RE: 142 Presumpscot LLC 5-25 meeting
TO The Planning Board -

D.
Lee Urban
Director of Planning & Development
City of Portland
Re: Coastal Equipment Corp. Expansion, 142 Presumpscot Street
ID # 2003-0104, CBL # 425-I-004

MARK GOLDSTEIN
COASTAL EQUIPMENT CORPORATION
WAREHOUSE ADDITION

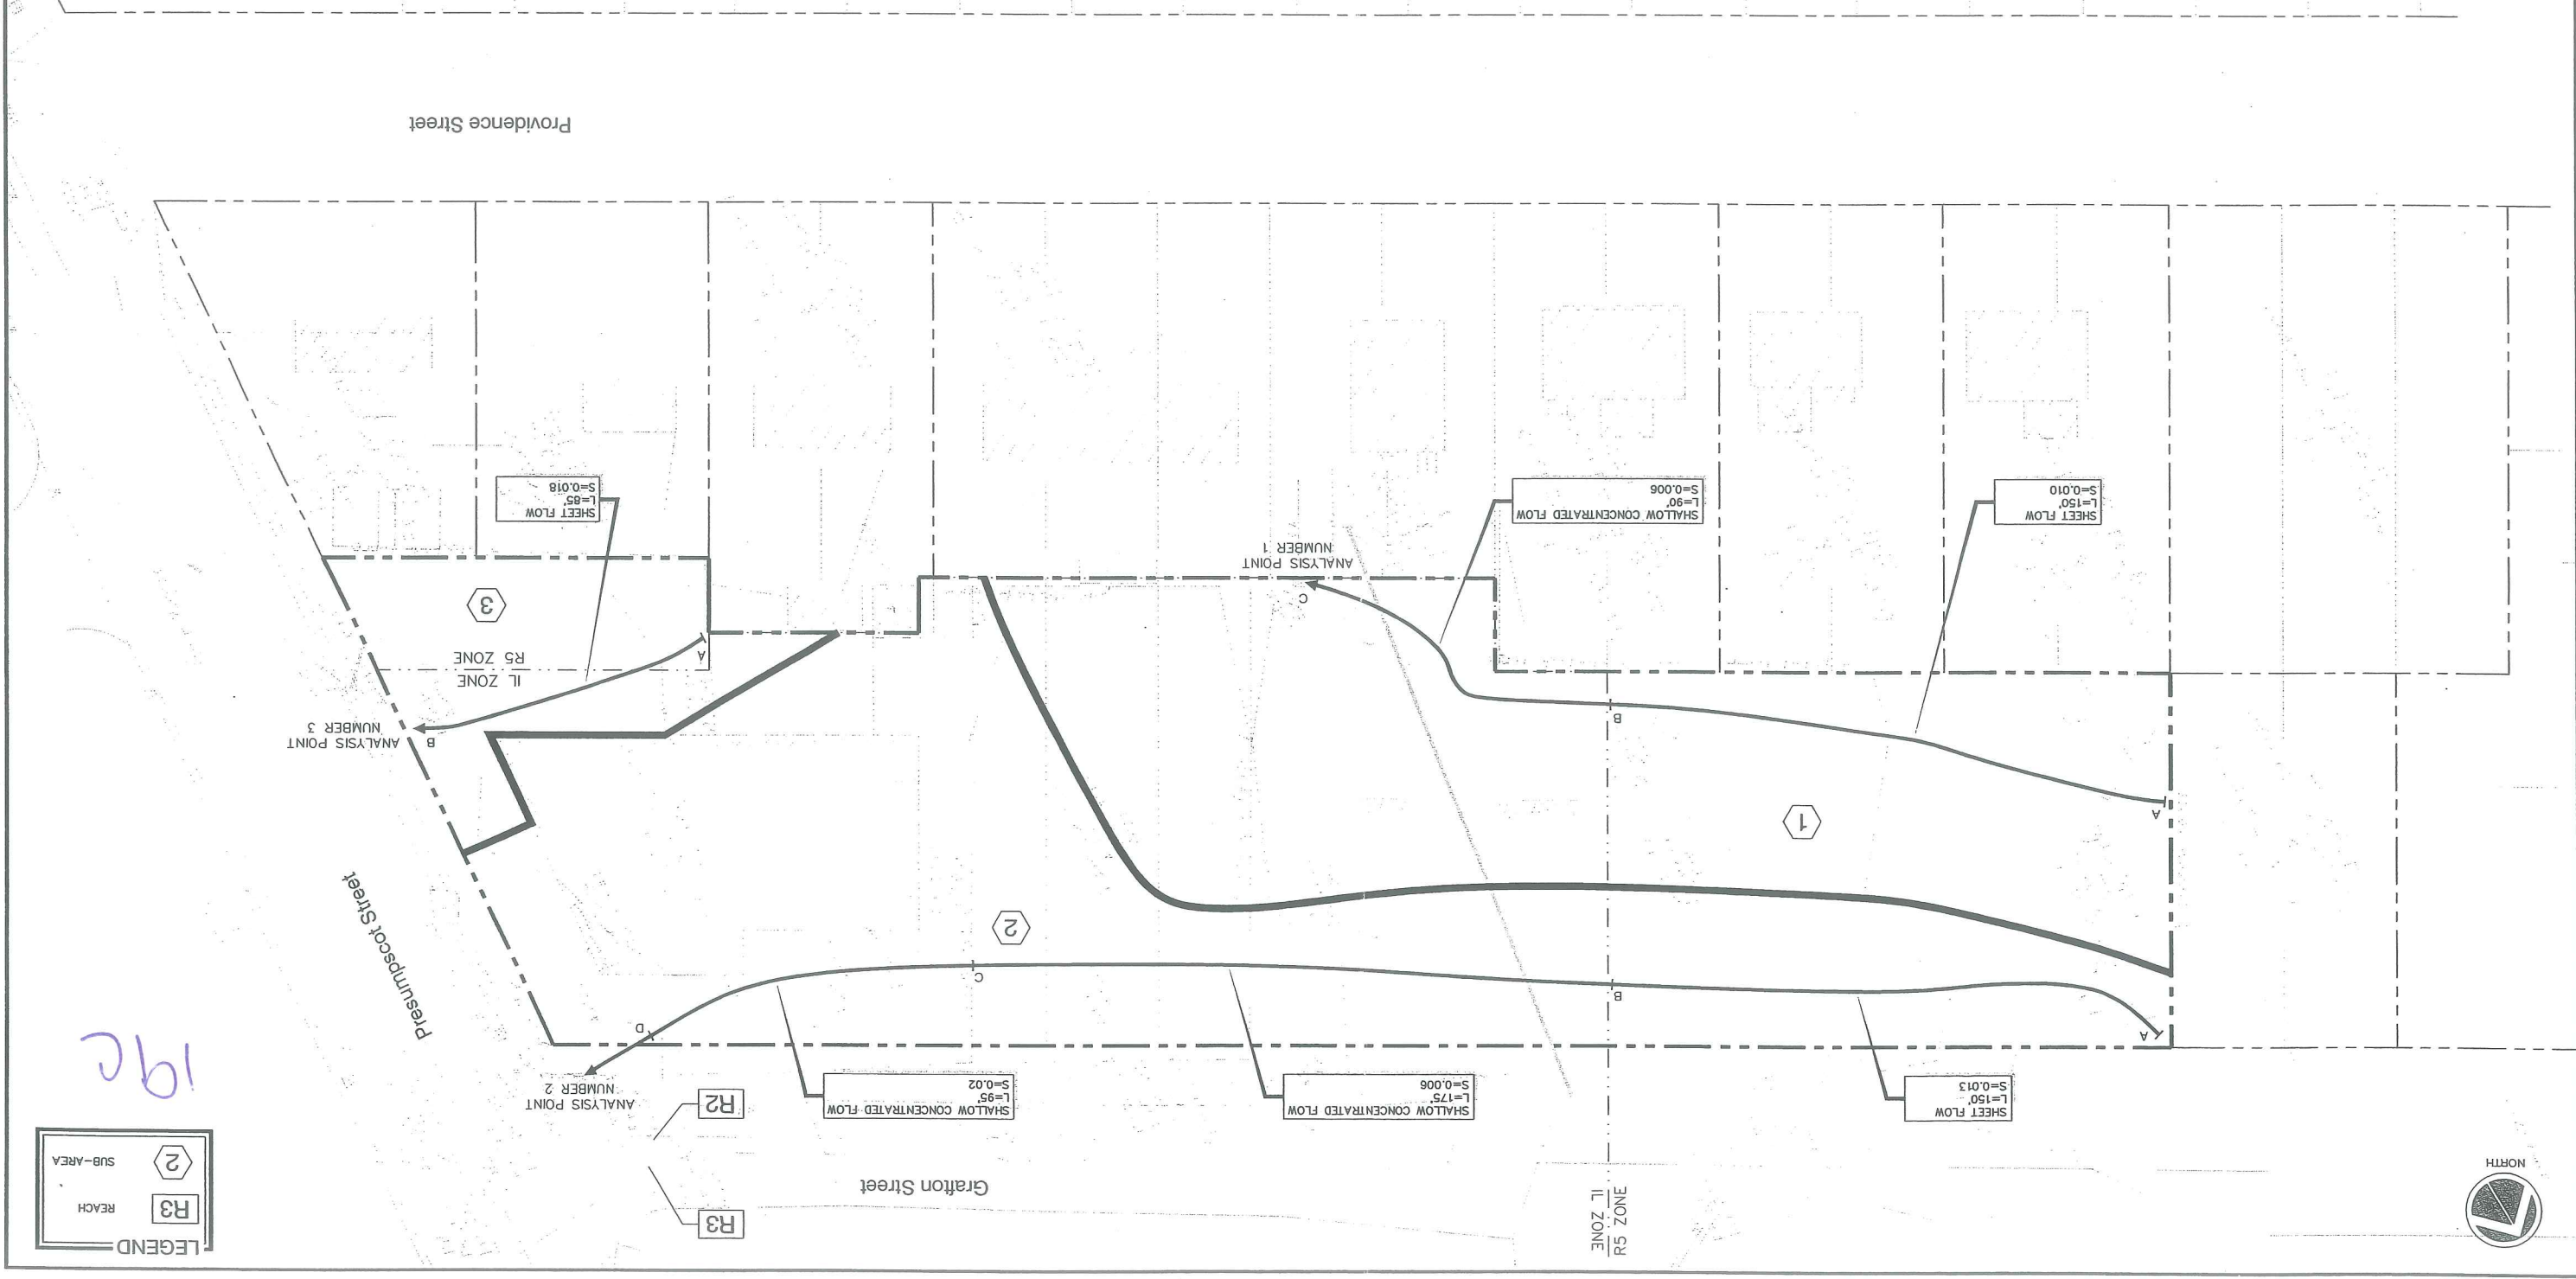
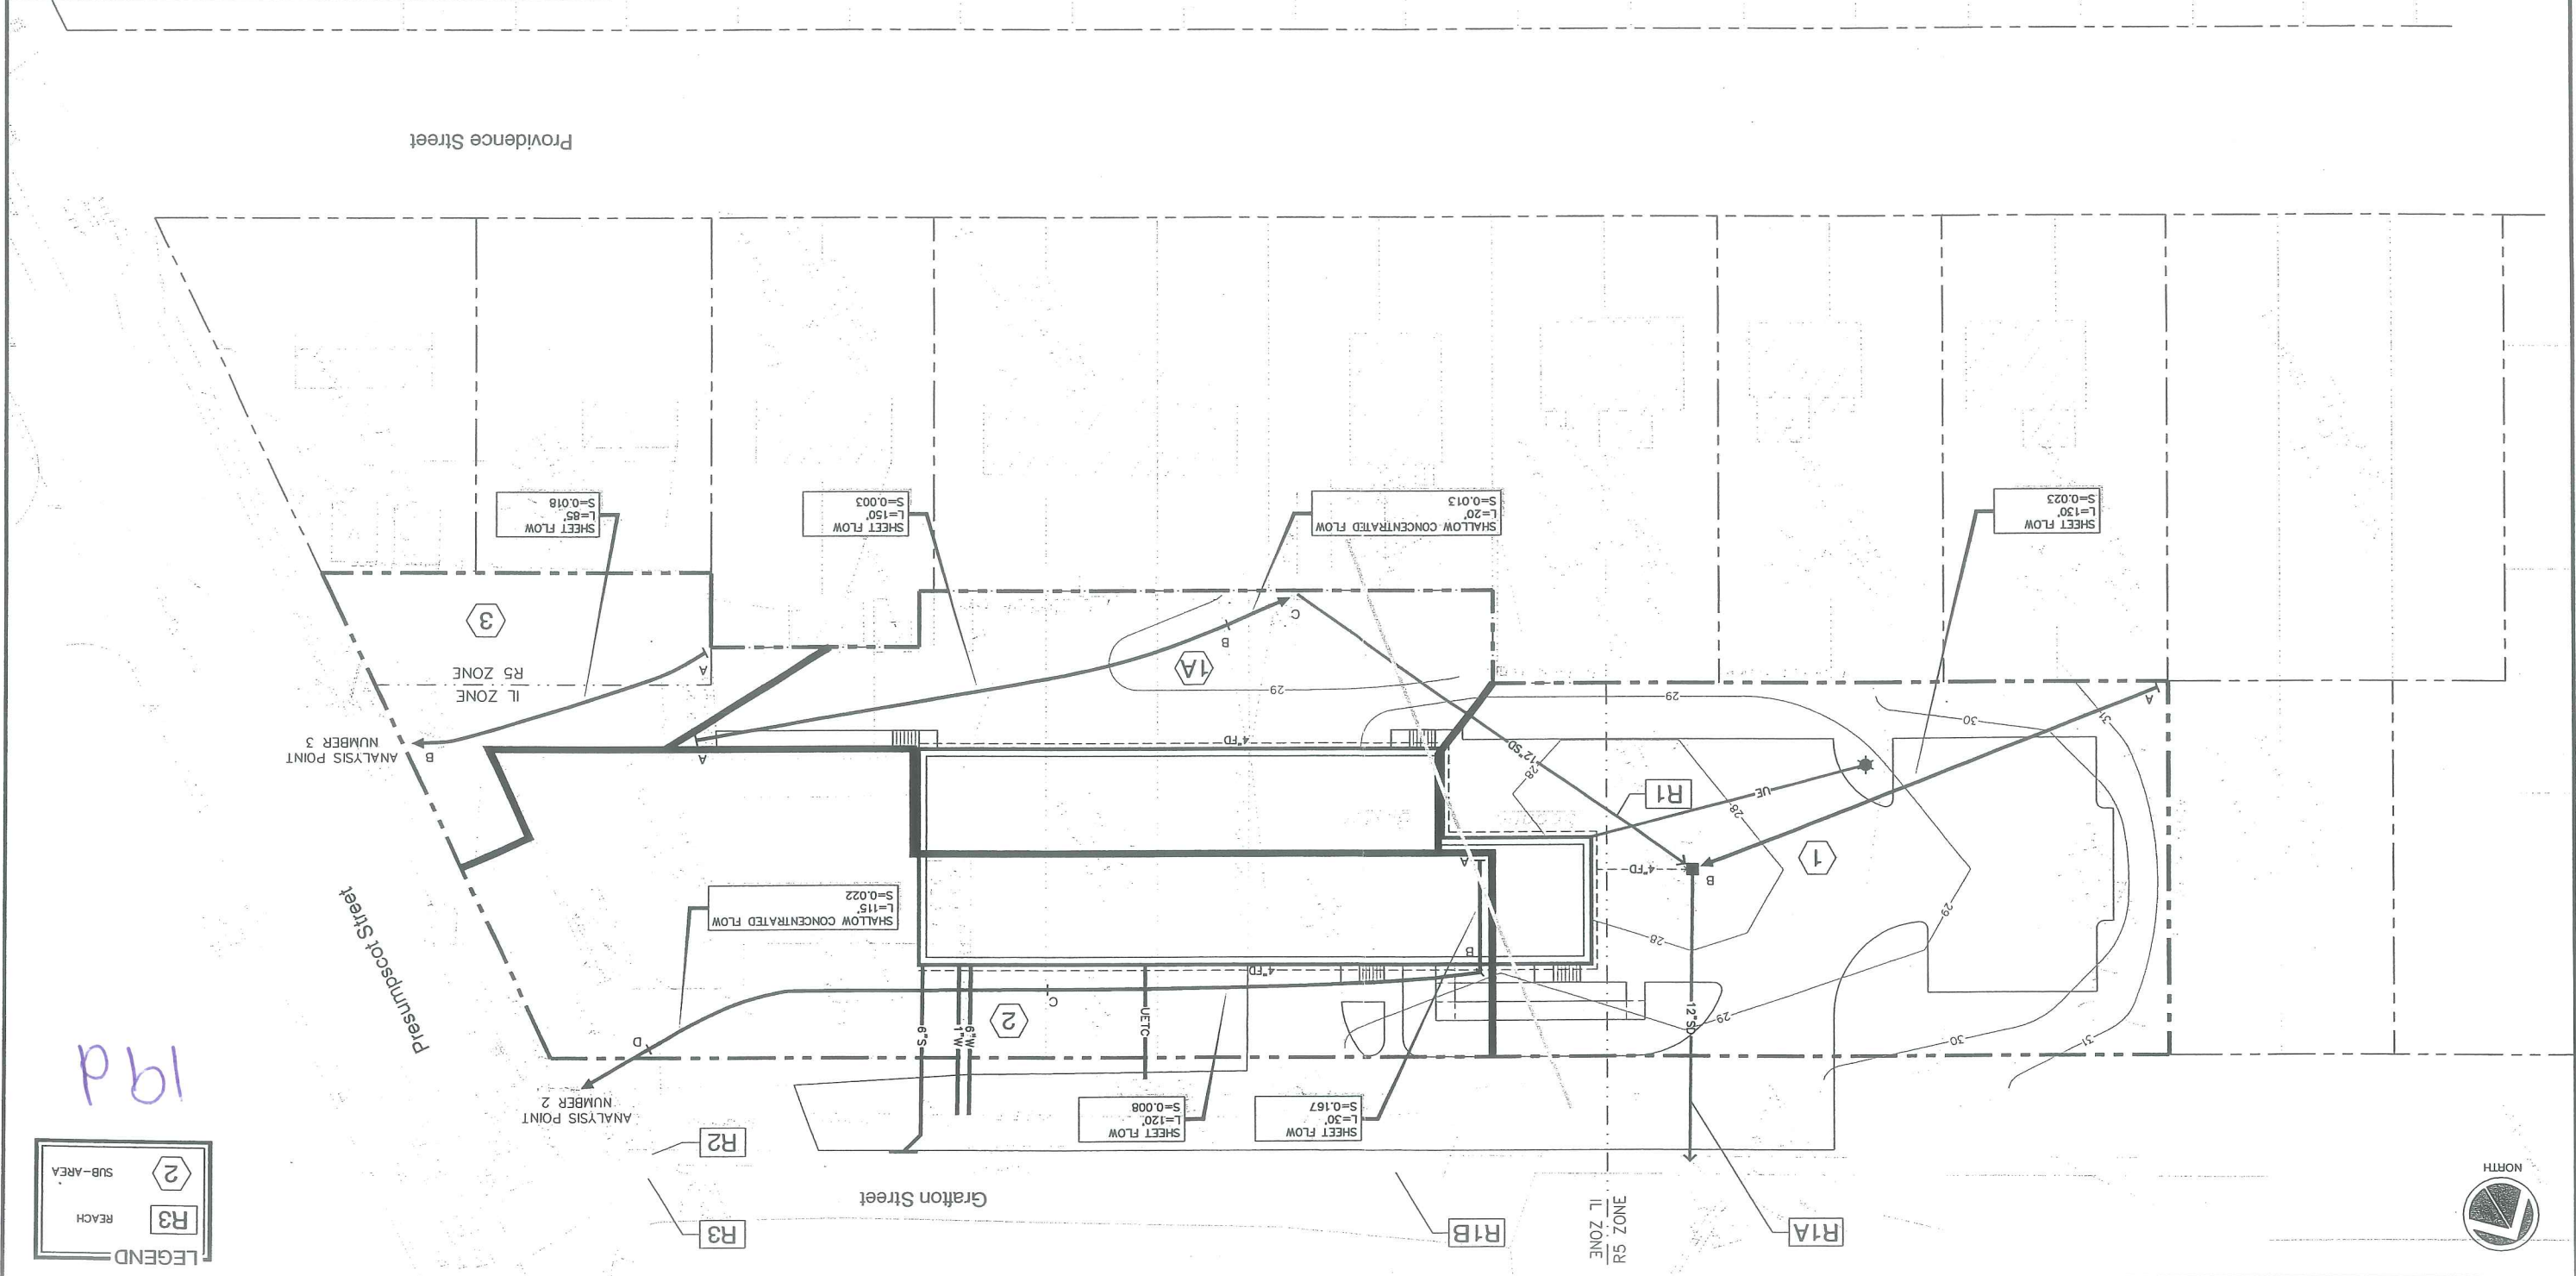
THE PRE AND POST DEVELOPMENT STORM DRAINAGE PLANS ARE INCORRECT IN THAT, SUBAREA # 2 DOES NOT FLOW FROM THE NORTH END OF THE PROPERTY TO ANALYSIS POINT # 2. ON PRESUMPCOT ST. THE NORTHERN HALF OF SUBAREA # 2 AND RUNOFF FROM THE EAST SIDE OF GRAFTON ST. FLOW TO A 15" FIELD DRAIN ON THE WEST SIDE OF GRAFTON ST. JUST PAST THE EXISTING CHAIN LINK FENCE..

10. Mr. Drake takes issue with the pre- and post-development storm drainage plans, again saying, essentially, that the storm water that flows from his property northerly of Grafton Street is not taken into account.

Please see response #6, above.
